SKETCH PLAN

ZOM BETHESDA
4900 MOORLAND LANE

PROJECT: ZOM Bethesda
Sketch Plan No. 320180050

RE: Sketch Plan No. 320180050
ZOM Bethesda

ARLINGTON ROAD - PROPOSED
TYPICAL CROSS SECTION

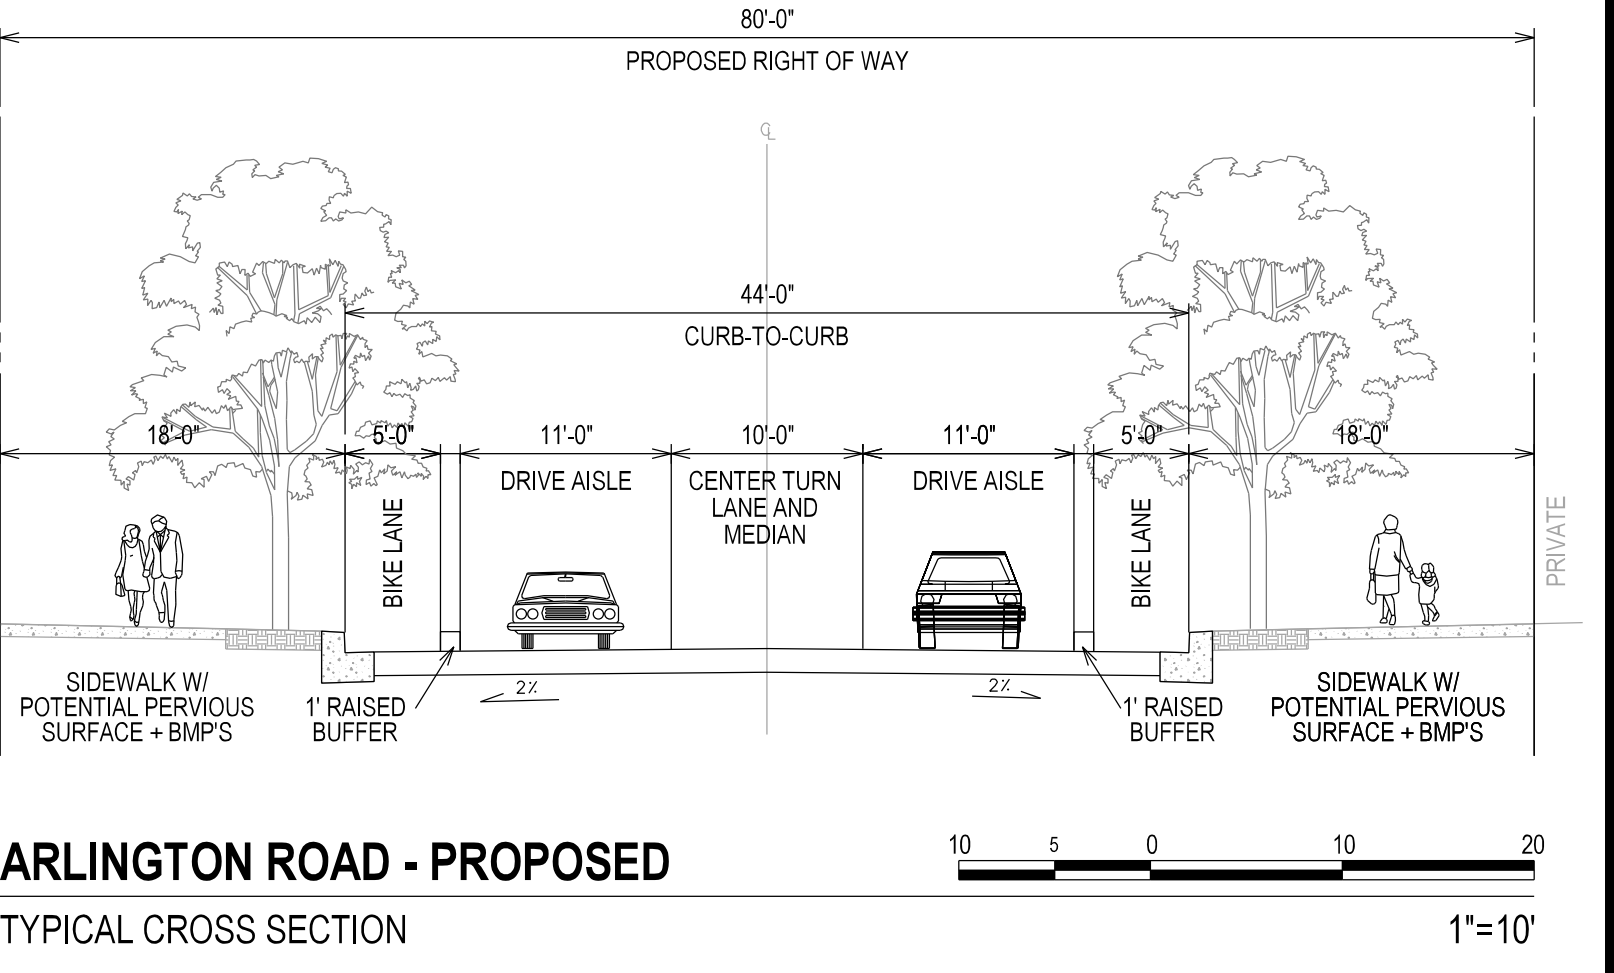
5. Arlington Road - Provide typical section for Arlington Road. Necessary dedication for Arlington Road in accordance with the master plan. Arlington Road is classified as an Arterial Road with 80 feet of right-of-way.
